# **ADDENDUM No. 1**

**CSP# 208056**

**ORG #380 WILMER-HUTCHINS HIGH SCHOOL**

CSP 208056, Org 380 – Wilmer Hutchins High School Renovation

**A2.02**  
**PROJECT NO.:** 2023

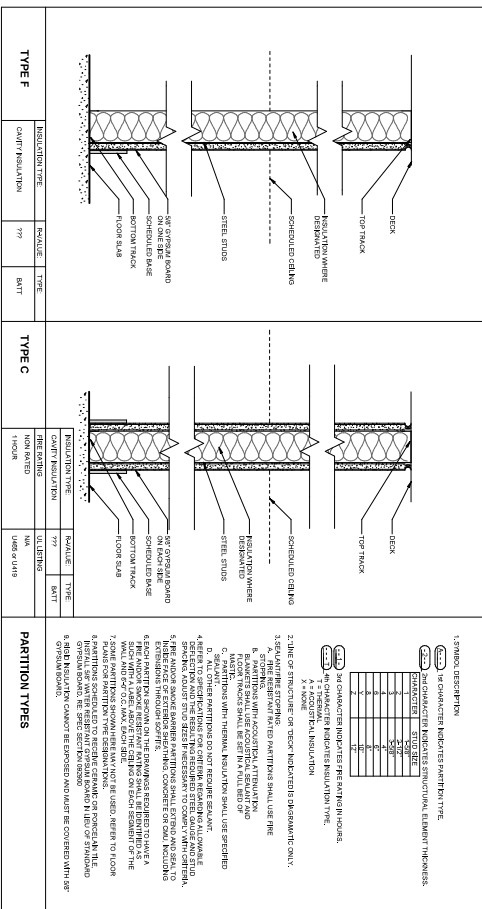
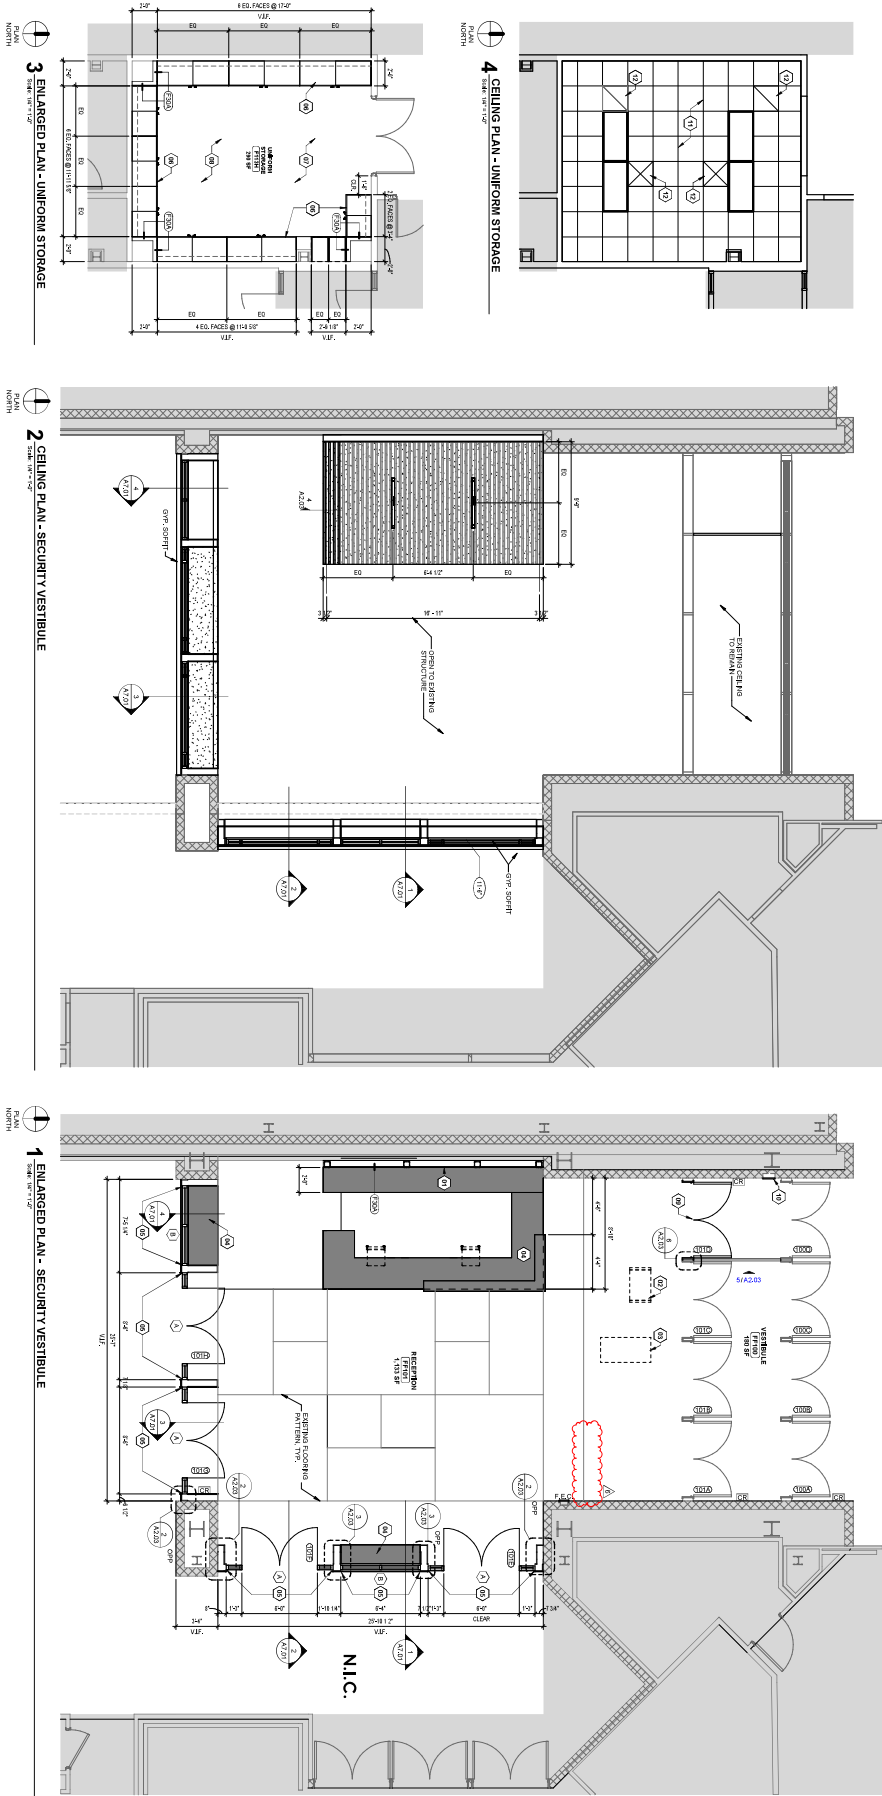
Removed note on 1/A2.02 for proposed location of fire panel. Refer to 1/FA1.01 for fire panel location.

### 3 TECHNOLOGY PLAN - SECURE VESTIBULE EAST

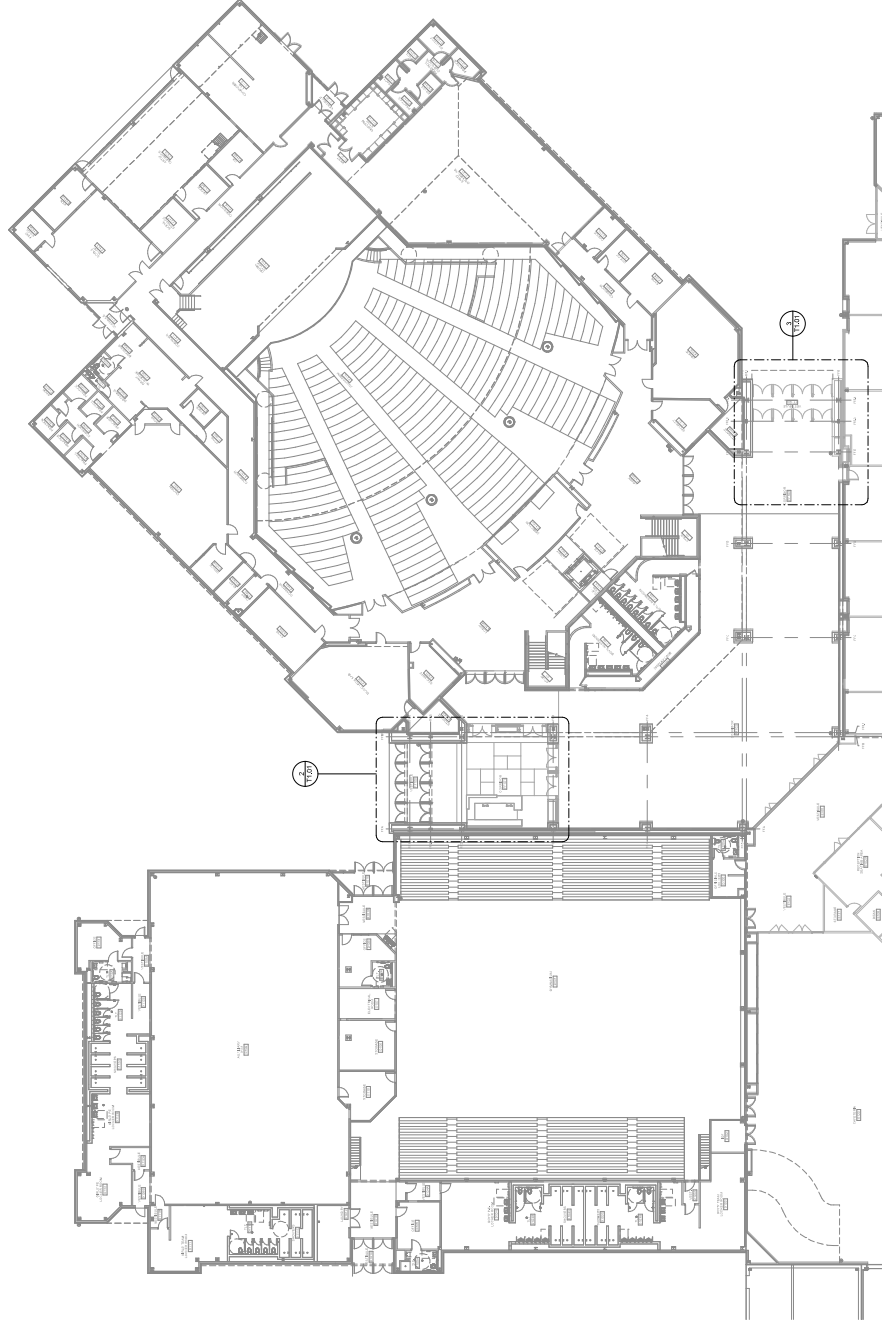
Updated enlarged plan 3/T1.01 to show temporary security devices in small vestibule.
